City Council
City of Bandon
March 22nd, 2021

Additional comments for the Public Hearing on Appeal of the Final Decision on February 22nd, 2021 of the Plan Review on Bandon Beach Hotel, 20-078 located at 1090 Portland Avenue SW in Bandon OR (Map Number 28S-15W-25CC/ taxlots 1600, 4100, 4900 and 4800).

From applicant's submitted plans for parking lot fencing and landscaping.

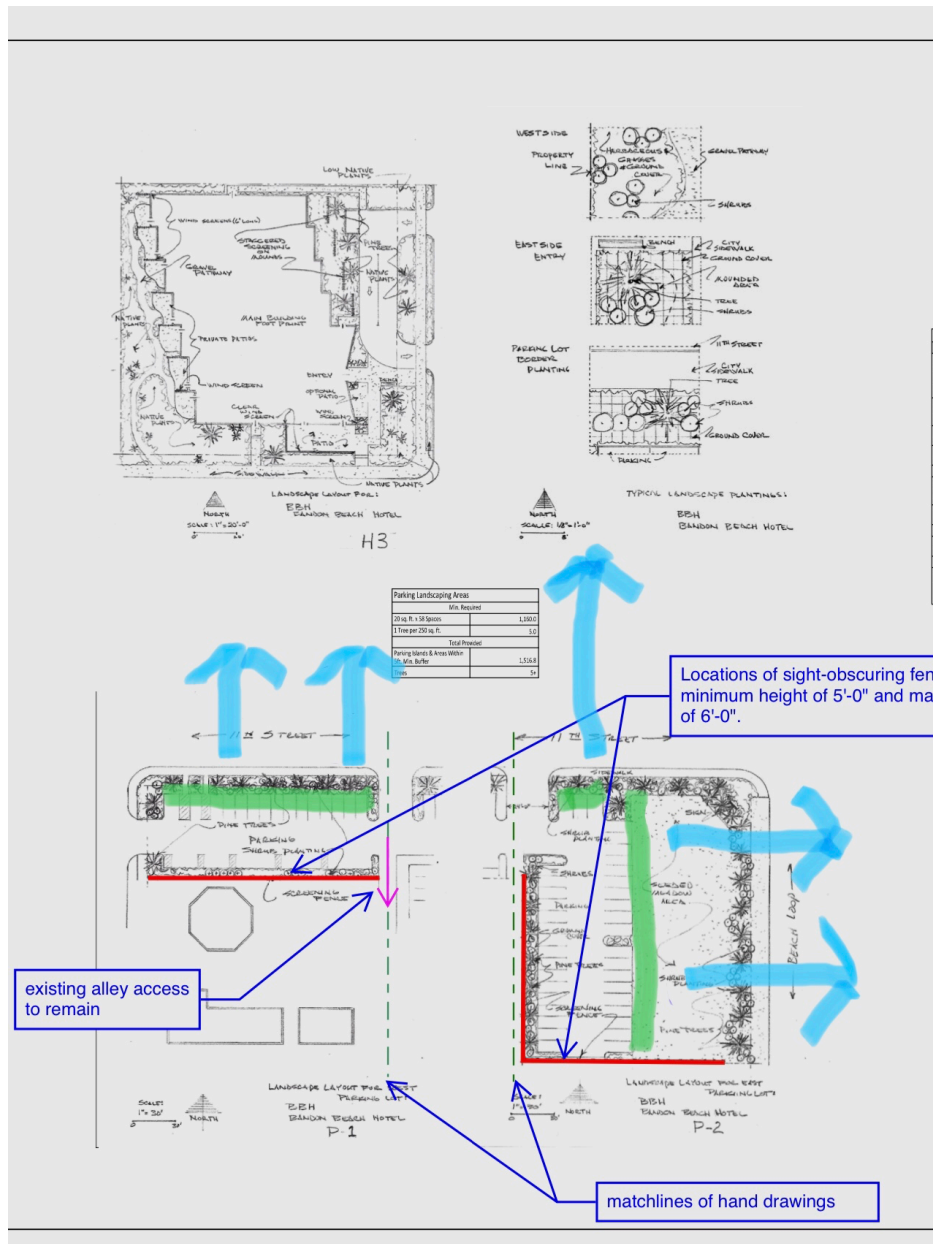
As I mentioned previously in my appeal letter fencing is proposed along the parking lot south of taxlots 4100 and 4800 where it abuts a residential zone and west of taxlots 4800 and 4900 where it abuts an alley next to a residential zone. But no fencing is included on the parking lot east of taxlots 4800 and 4900 or north of taxlots 4100 and 4900 where residential zones are to the east and north of the development so the above applicable criteria hasn't been met.

Again as I mentioned previously in my appeal letter fencing is proposed along the parking lot south of taxlots 4100 and 4800 where it is adjacent to a residential zone or adjacent to dwellings and west of taxlots 4800 and 4900 where it abuts an alley next to a residential zone or adjacent to dwellings. But no fencing is included on the parking lot east of taxlots 4800 and 4900 or north of taxlots 4100 and 4900 where it is adjacent to a residential zone or adjacent to dwellings are to the east and north of the development so the above applicable criteria hasn't been met.

Red lines show where applicant is proposing fencing to block headlights from shining on adjacent residential properties (south of taxlot 4100, west of taxlots 4900 and 4800 across alley and south of taxlot 4800).

Green lines show areas of parking lot without fencing with light blue arrow lines showing direction that headlights would be shining onto adjacent residential properties across Beach Loop Drive to the east and 11th Street to the north ending up causing a disturbance or adverse effect on the neighboring residences from the parking lot development.
